KWM-380 TRANSCEIVER (622-5093-101)
HF-380 TRANSCEIVER (622-3580-101)
RECEIVER-EXCITER CIRCUIT CARD A3 (638-6908-001)

SERVICE BULLETIN NO 1**PRODUCT IMPROVEMENT**

This is a nonmandatory service bulletin which applies to the following:

P/O Receiver-Exciter Circuit Card A3.
Figure 1 (Sheet 2)

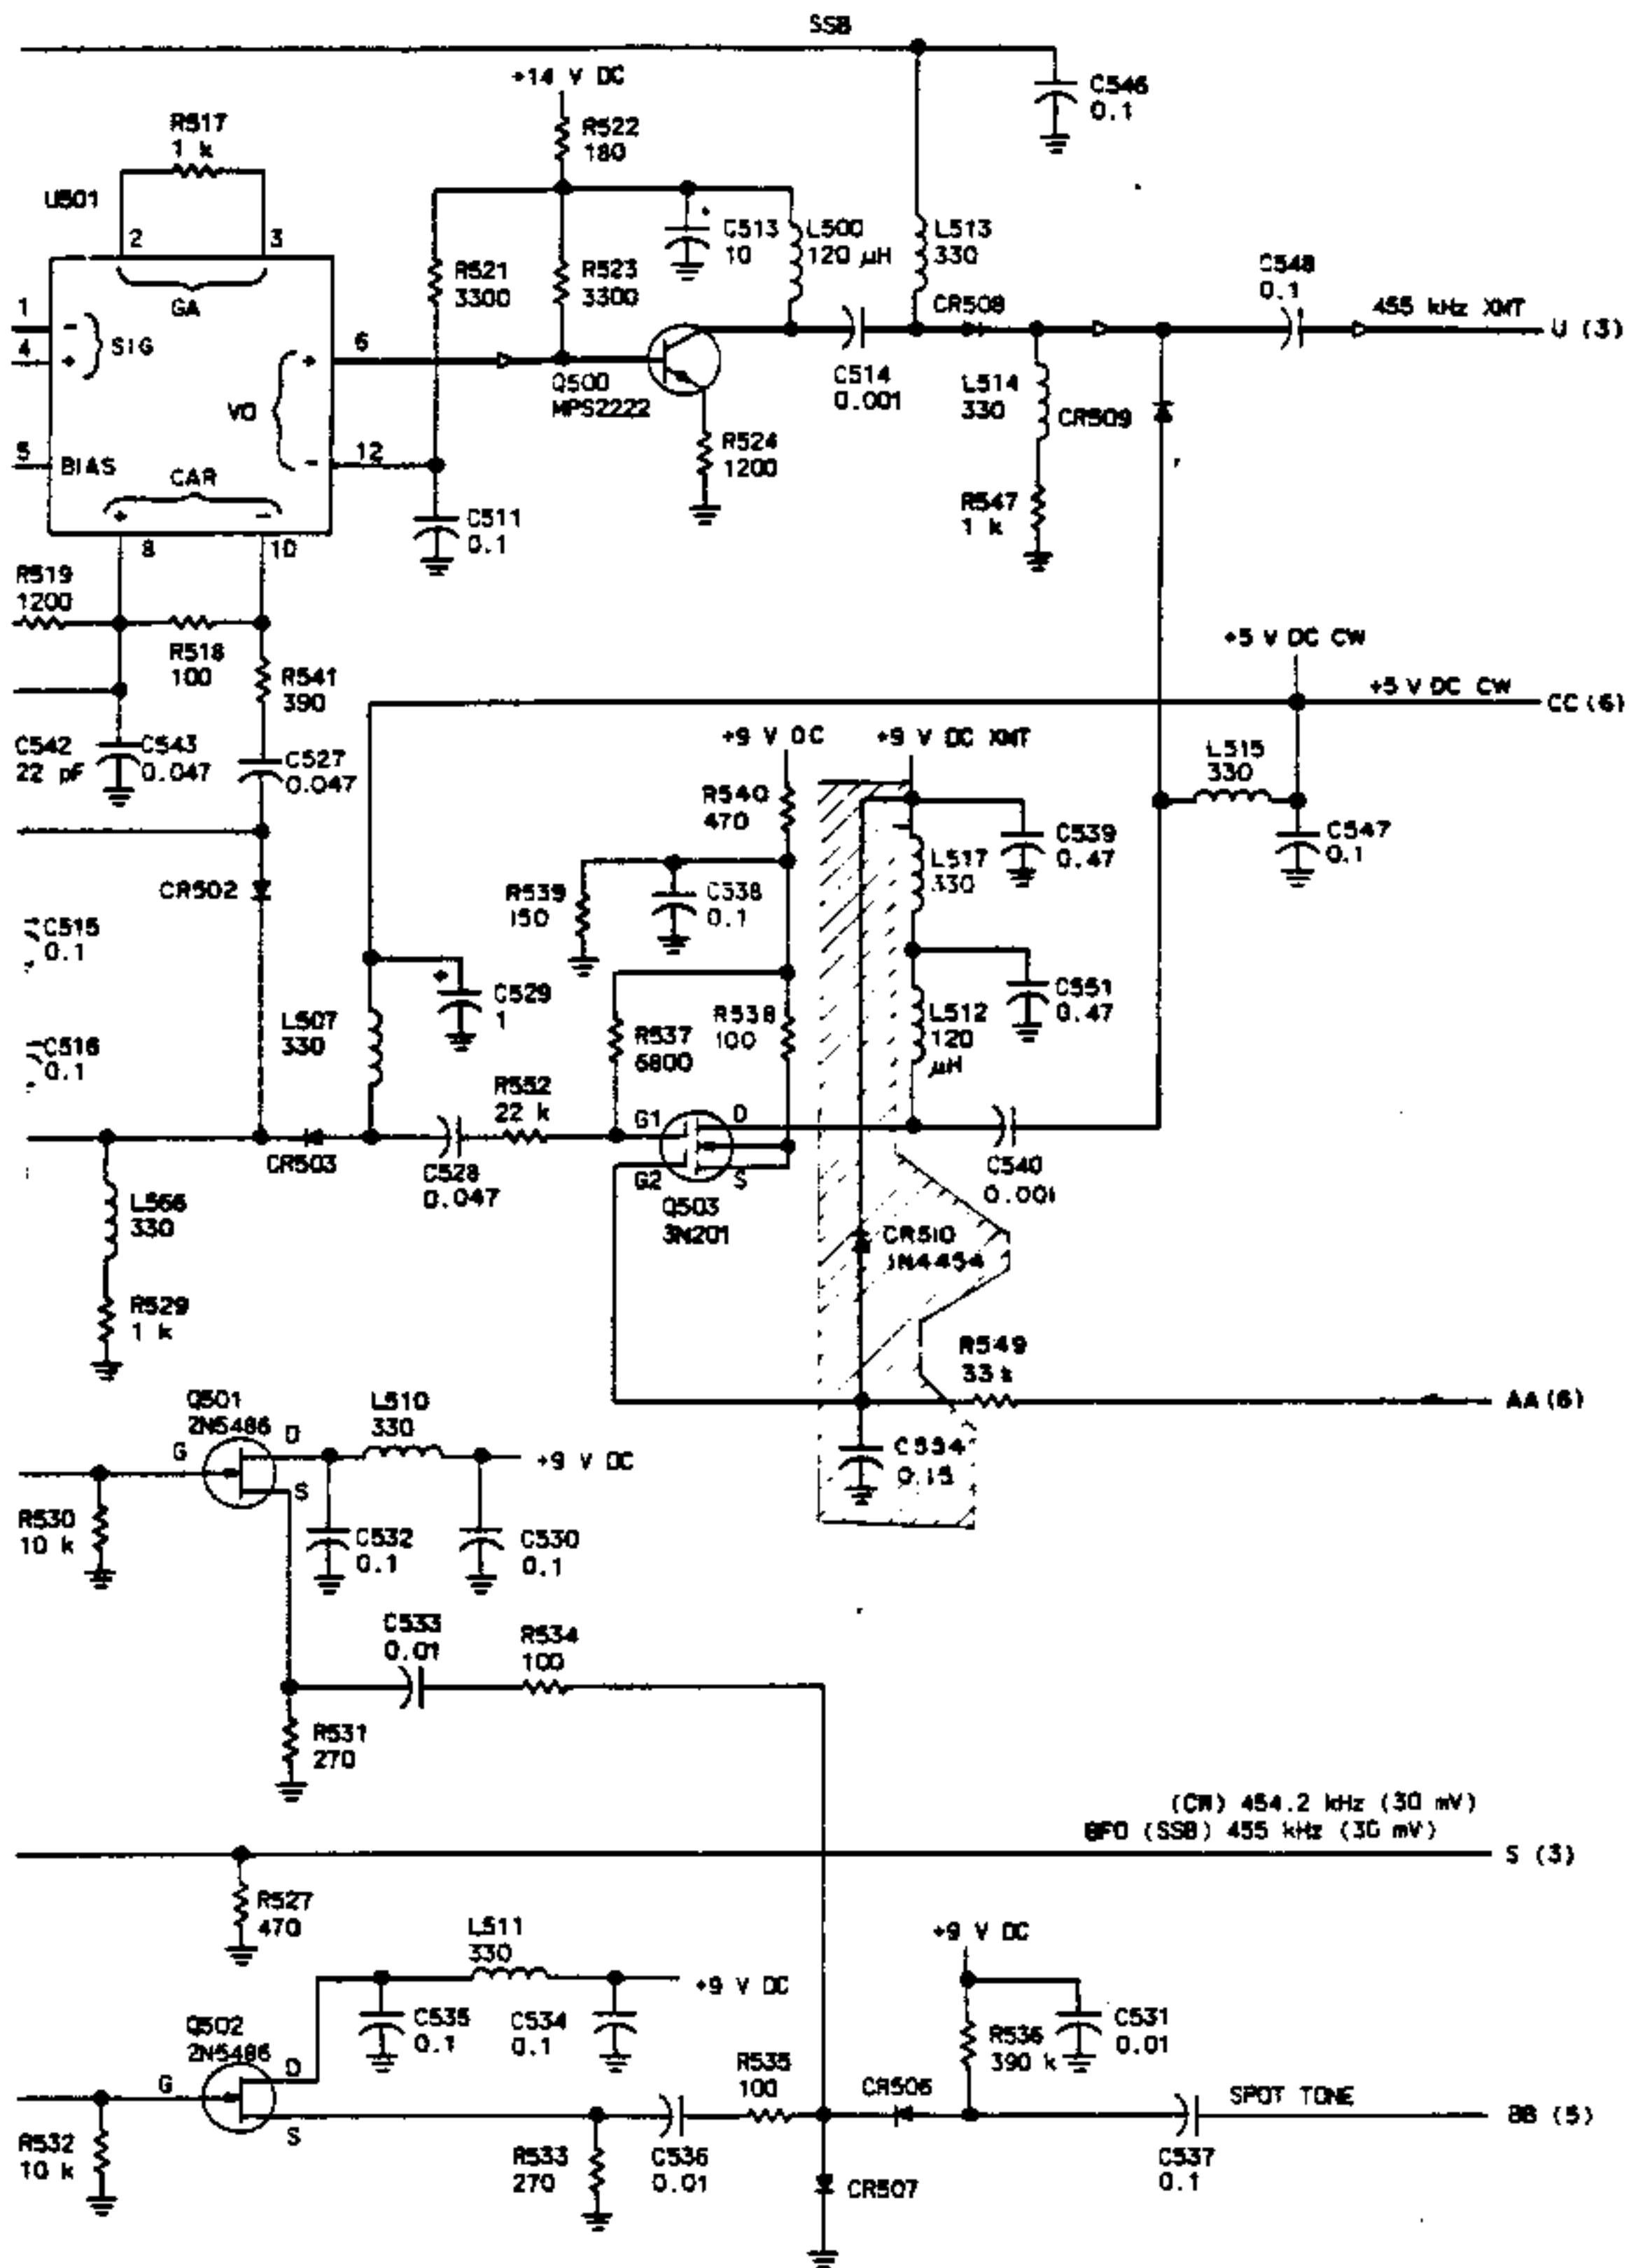
- H. Refer to figure 1, detail M, for location and install five square pins (372-2601-045). Lift component leads, as necessary, and reconnect the leads to the pins after the square pins are installed.

- N. Install 0.1- μ F capacitor C988 (913-5019-440) from the square pin at the bottom lead of R925 to the square pin below R968.
- O. Install 1.5- μ F capacitor C989 (184-9102-800) with the positive lead connected to the square pin at the right-hand lead of R926 and the other lead connected to the square pin at the bottom of R925. Refer to figure 1, detail M, section D-D.
